**Certificate of Appropriateness Application**

BAR 08-08-01

201 East Water Street  
TM 28 P 31

Minor Family Hotels, Applicant  
Canopy modification

3 CANOPY SECTION THRU OUTSIDE EDGE

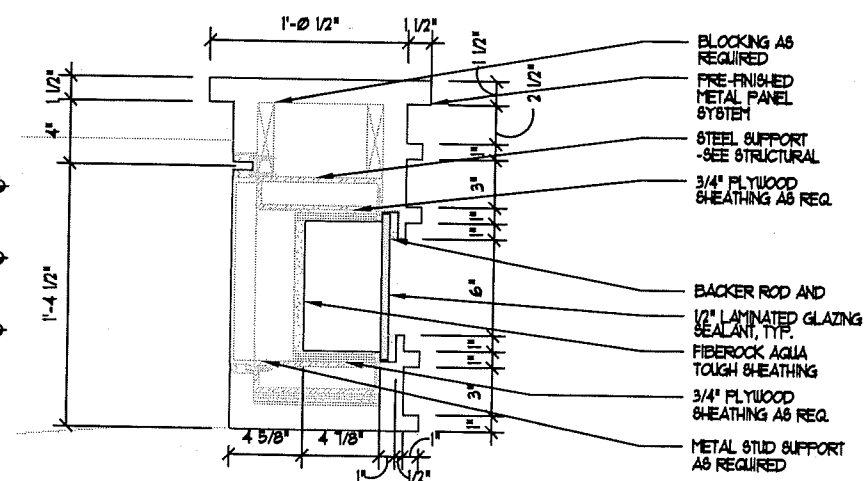
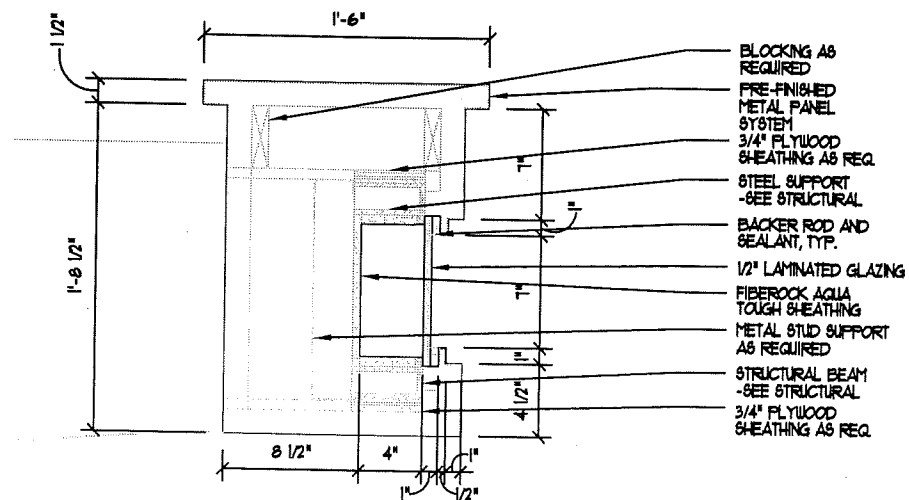
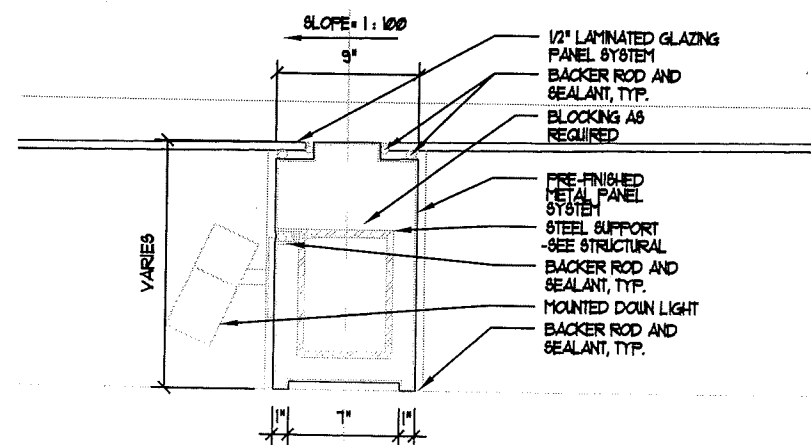
The BAR noted it would be beneficial if the canopy was made more consistent with the language of the existing building, specifically: the little lit medallions not found anywhere else on the building; the glass edge; the dimples on the edge; and the thickness of the edge that is greater than previously approved, and not supported by other detailing on the building.

1 CANOPY REFLECTED CEILING LIGHTING PLAN

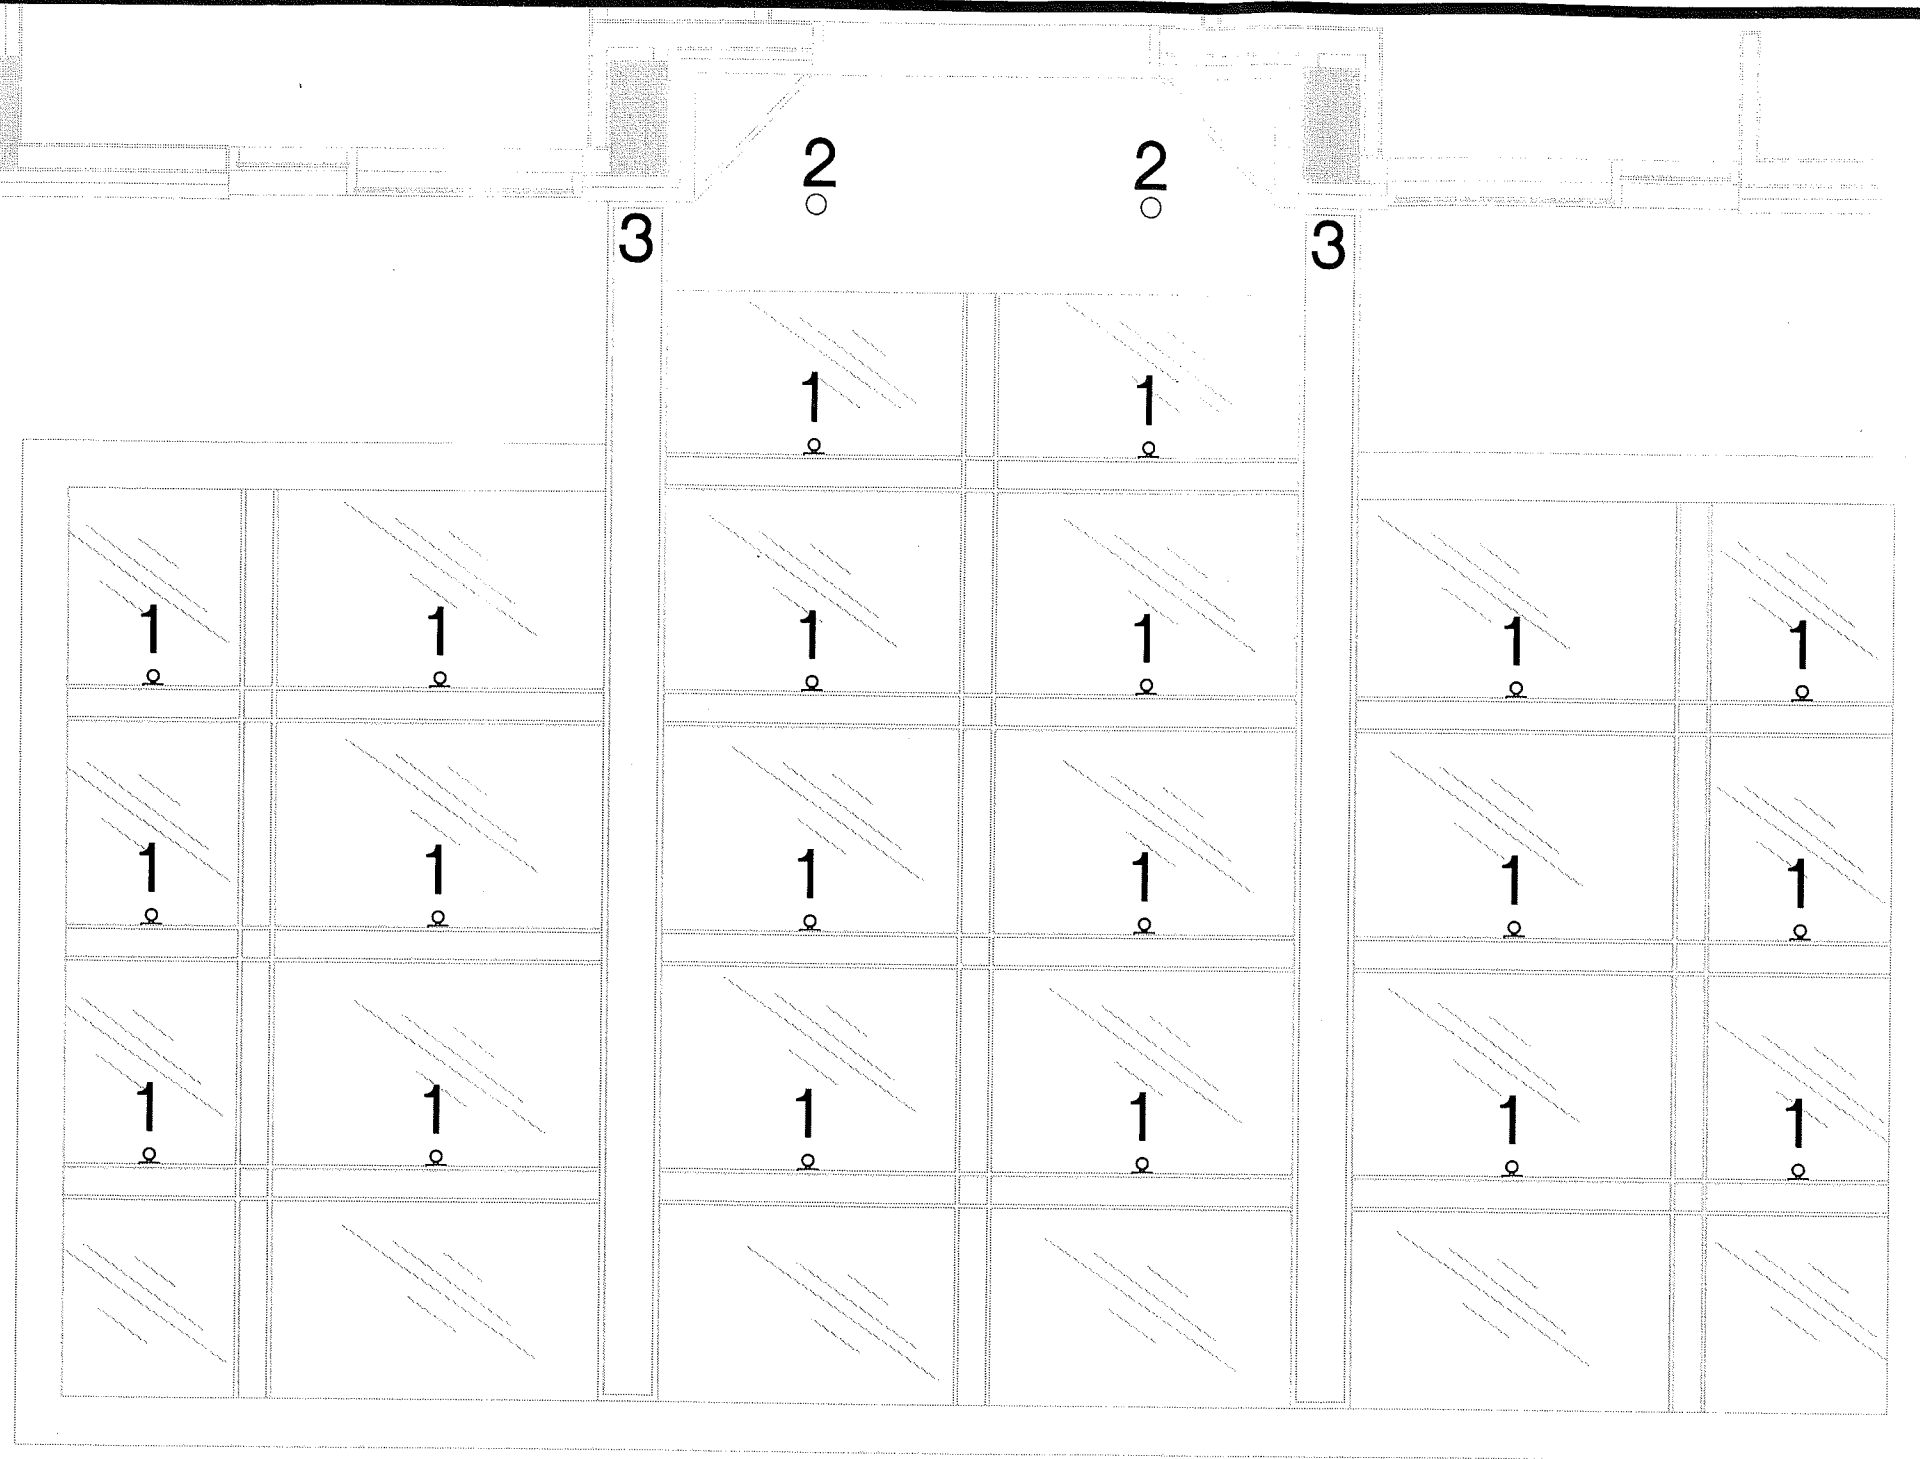
Can you find out the lumens from the sconces? Our ordinance allows 3000 lumens without shielding, equivalent to 35 w fluorescent lamps.

The architectural sconce we have preliminarily selected is the Mentor Series from Winona Lighting. The model we have used in our preliminary design work includes a single F32T8/3K lamp (they also catalog 2-lamp versions). This has an initial 2850 lumens when operated on a standard electronic ballast. We will be specifying an electronic low power factor ballast which reduces the maximum lumen output to approximately 2300 lumens.

I will be returning to my office on Monday and will get back to you then. We can meet the City's 3000 lumen limit with this sconce.

The Landmark Hotel - Entry Canopy Lighting Calucation  
 Charlottesville, VA  
 Scale: 1/8" = 1'-0"

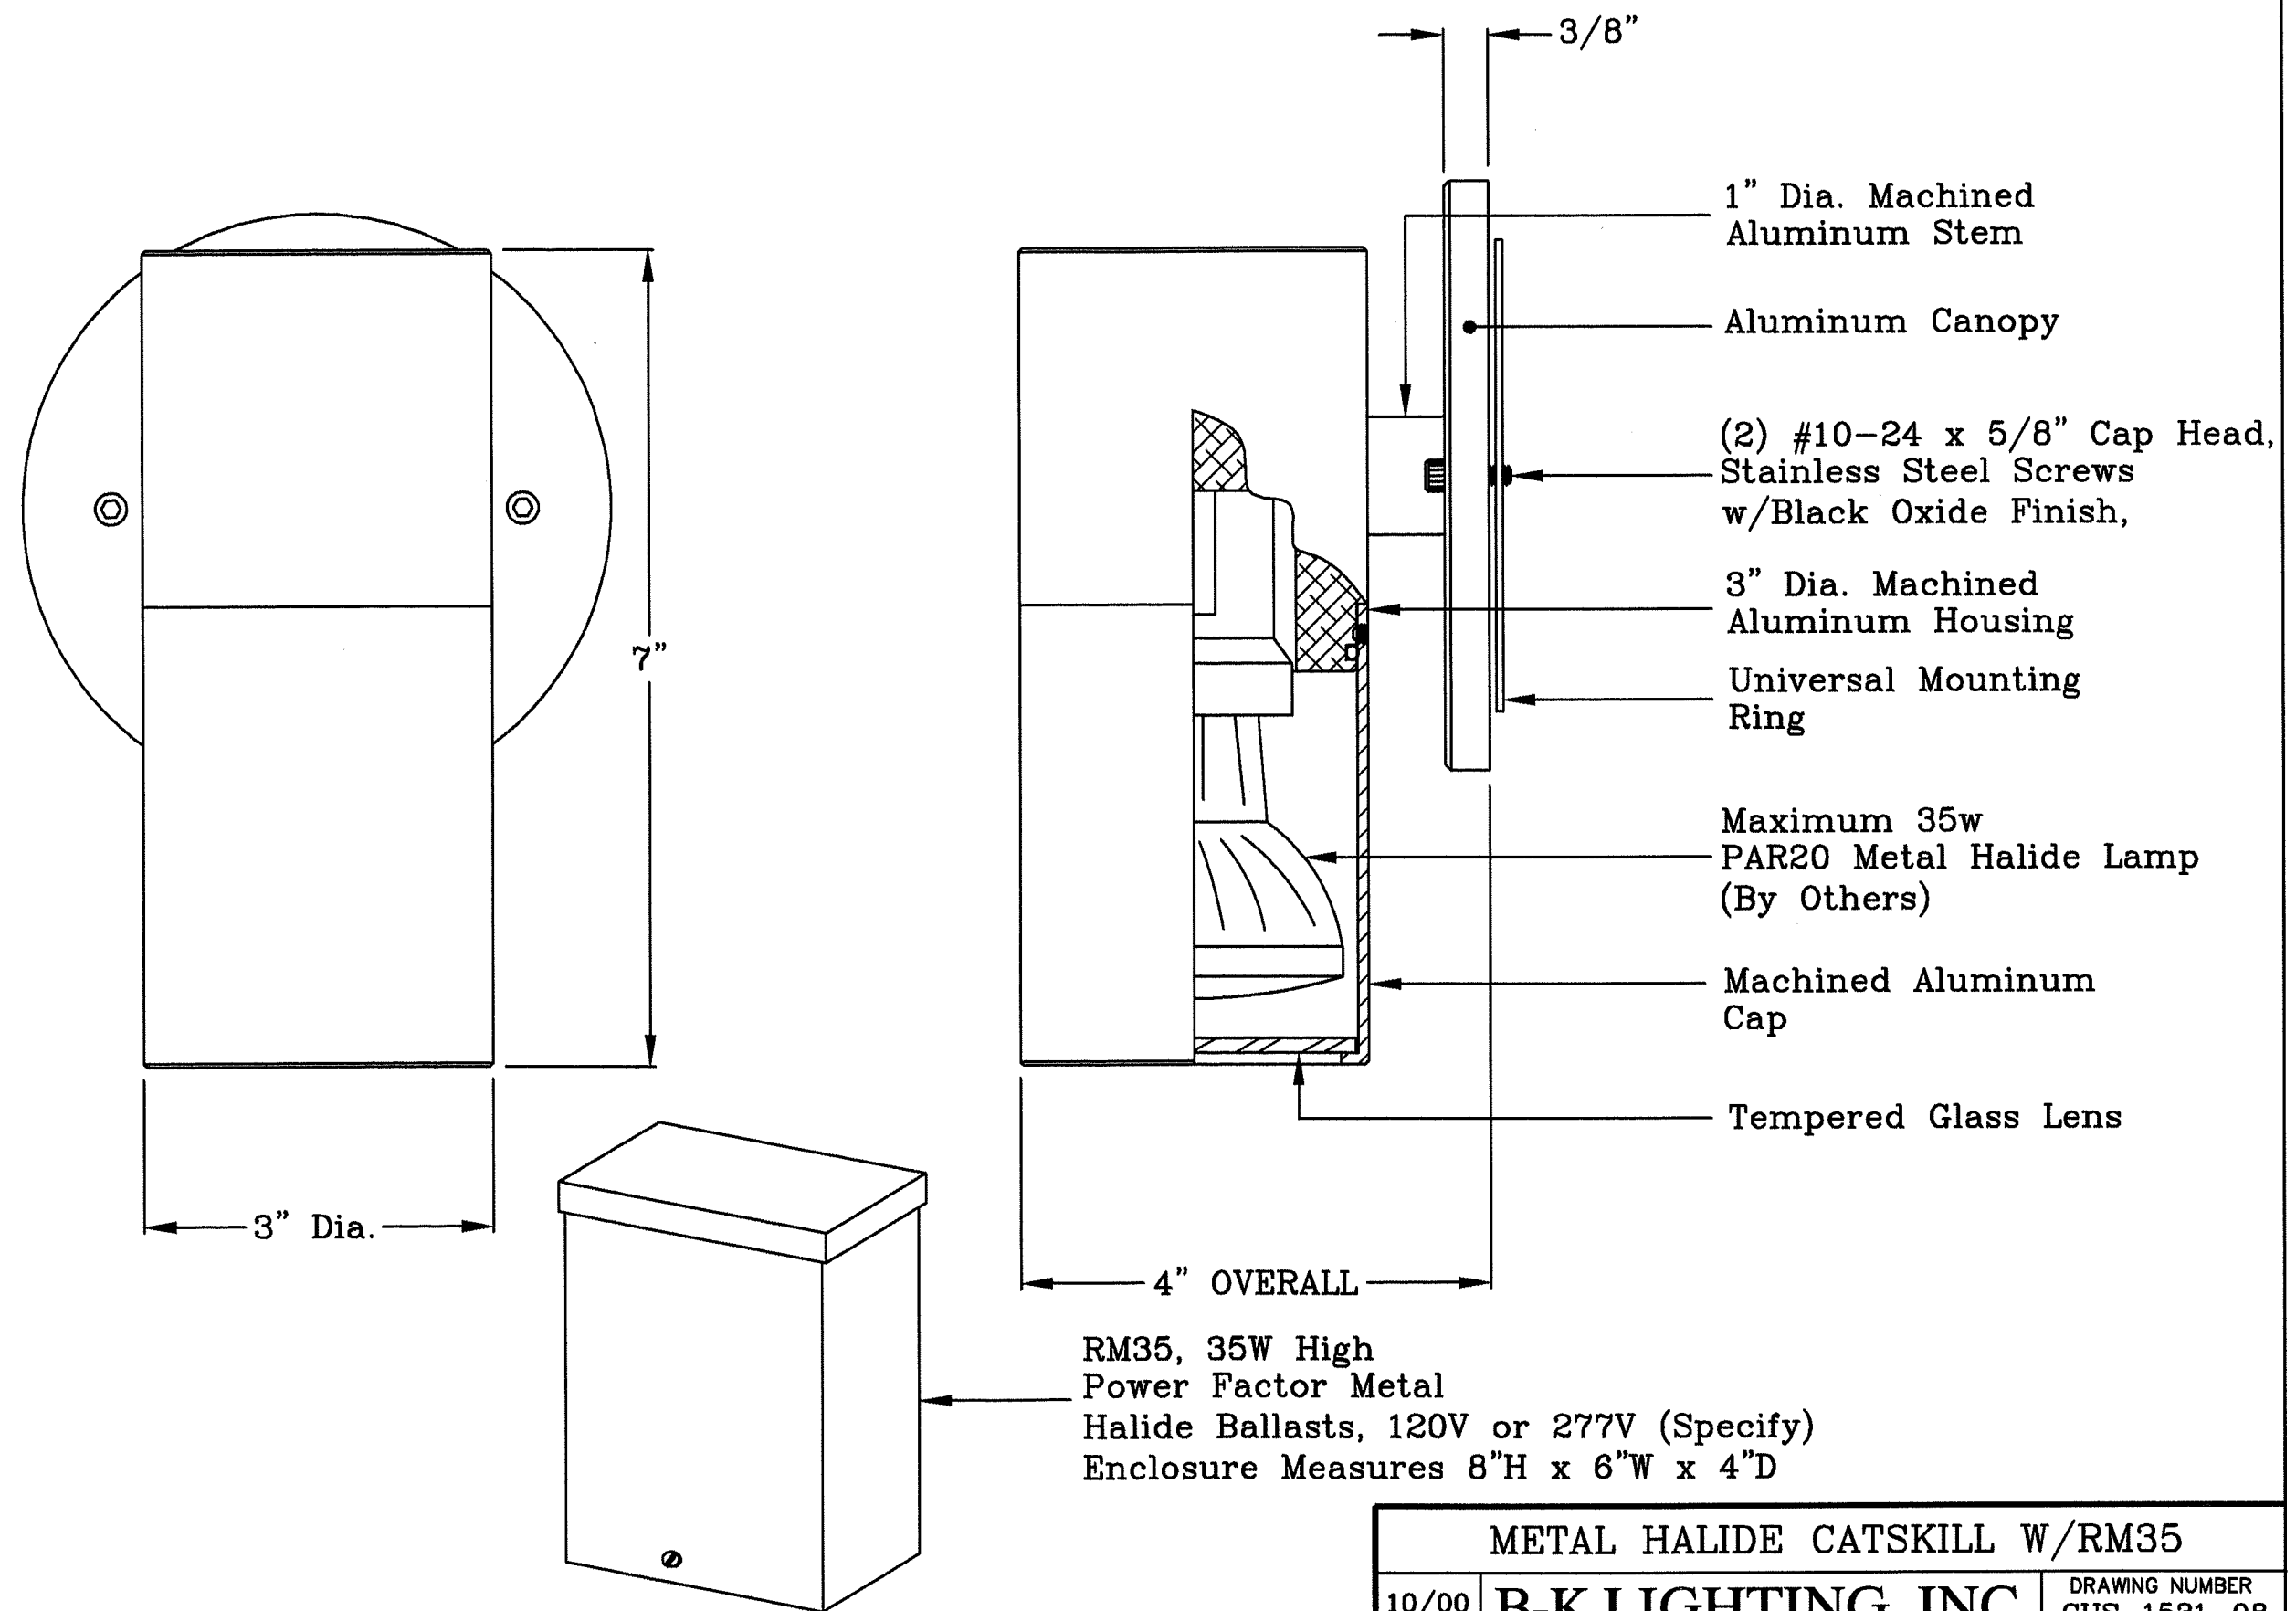
The applicant has said that the internally lit sconce lighting will meet the dark sky lumens requirements. The downlights are much preferred to the previous submittal that had internally lit canopy lighting. The applicant has submitted a photometric plan. For comparison purposes, the Illuminating Engineering Society of North America (IESNA) has established that an illumination level of 20 fc is all that is needed for service station pump islands with dark surroundings, and 30 fc for pump islands with bright surroundings. Therefore, the range under the canopy (max. 34.4) is within reason. However, per the zoning ordinance, the maximum footcandle level permitted to spill onto public rights of way is 1/2 footcandle. That amount is exceeded in front of the canopy, and should be adjusted.
